Access Compliance Report Public Rights-of-Way (Curb Ramps)

Main Street: O_NEILL_DR		Cross Street: SIENNA_PKWY		Location:	NW
ADA ID: RPRK211111131139	Ramp Type: Type 1 - Perpendicular	Initial Pass/Fail: Fail	Overall Compliance: No	Severity Score:	15

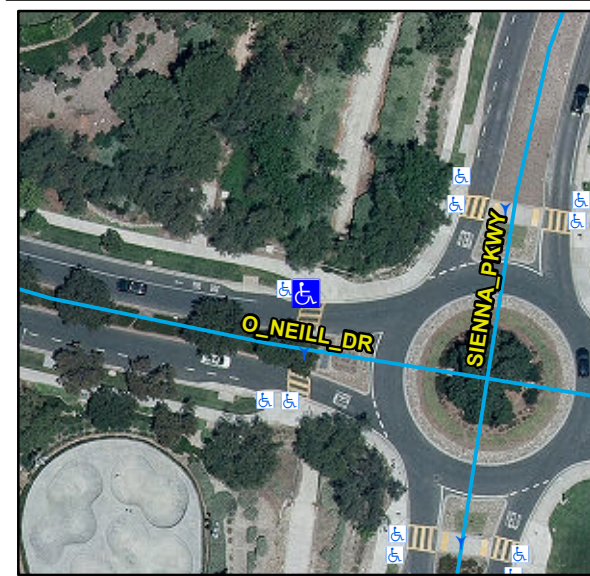
Compliance	Description	Data	Compliance	Description	Data
N/A	Ramp Length (in)	86	N/A	Flare Type LT	
Yes	Ramp Width (in)	50			N/A
No	Ramp Run Slope (%)	8.8	N/A	Flare Slope LT (%)	N/A
Yes	Ramp Cross Slope (%)	0.3	N/A	Flare Traversable LT	N/A
N/A	Landing Present	N/A	N/A	Flare Type RT	
N/A	Landing Length (in)	N/A			N/A
N/A	Landing Width (in)	N/A	N/A	Flare Slope RT (%)	N/A
N/A	Landing Run Slope (%)	N/A	N/A	Flare Traversable RT	N/A
N/A	Landing Cross Slope (%)	N/A	N/A	DWS Provided	N/A
N/A	Landing Movement Obstructed?	N/A	N/A	DWS Contrast	N/A
	Landing Movement Type	N/A	N/A	DWS Length (in)	N/A
N/A	Landing Shared	N/A	N/A	DWS Full Width	N/A
N/A	Clear Space	N/A	N/A	DWS Offset Left (in)	N/A
N/A	Clear Space To Crosswalk (in)	N/A	N/A	DWS Offset Right (in)	N/A
N/A	Marked Crosswalk 1	Yes	N/A	Marked Crosswalk 2	N/A
	Crossing 1 Direction	S		Crossing 2 Direction	N/A
	Marked Crosswalk 1 Width (in)	144		Marked Crosswalk 2 Width (in)	N/A

N/A	Ramp Inside Crosswalk 1	Yes	Yes	Ramp Inside Crosswalk 2	N/A
	Crossing 1 Slope (%)	1.6		Crossing 2 Slope (%)	N/A
	Crossing 1 Cross Slope (%)	0.9		Crossing 2 Cross Slope (%)	N/A
N/A	Gutter Ponding	N/A	No	Curb Slope	5.8
Yes	Gutter Lip Height (in)	0		Road Run Slope (%)	N/A
N/A	Gutter Run Slope (%)	N/A		Road Cross Slope (%)	N/A
N/A	Gutter Cross Slope (%)	N/A			
Yes	Overall Surface Condition: Acceptable		Yes	Perp Joint Present	Yes
	Cross Gutter Present?	No		Spandrel Present?	No
	Replace Cross Gutter?	N/A		Replace Spandrel?	N/A

Remove & Replace Entire Ramp.

R304.2.2, STD 1115
